# T&S BRASS AND BRONZE WORKS, INC.

**000764-20**

Product Specifications:  
B-0290 Removable Seat

Note: (2) Different B-0290 Seats, as of March 1997

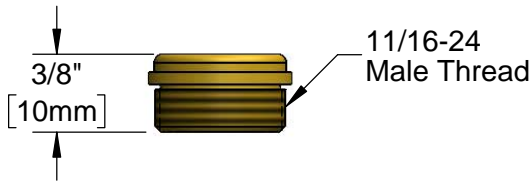
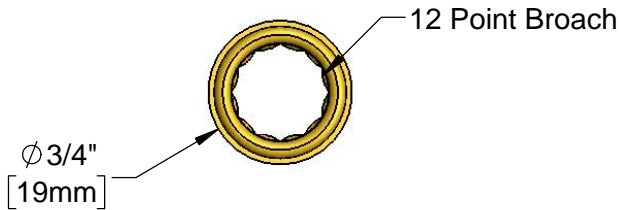
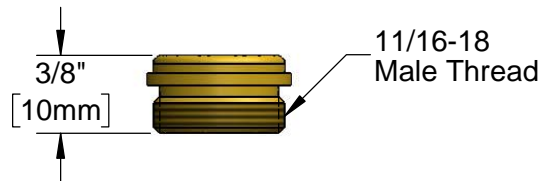
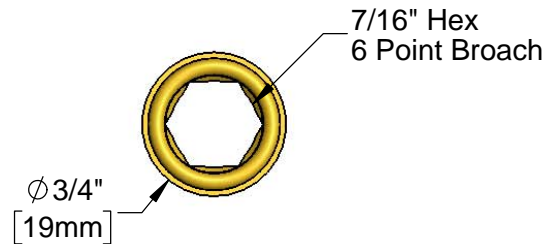
<u>Old Seats</u>	<u>New Seats</u>
Broach	12 point	6 point
Threads	24 per Inch 	18 per Inch

Old Seats Only Fit Old Faucets. New Seats Only Fit New Ones. Since We Weren't Sure Which Body You Would Be Repairing Today, We Have Included Both Types.
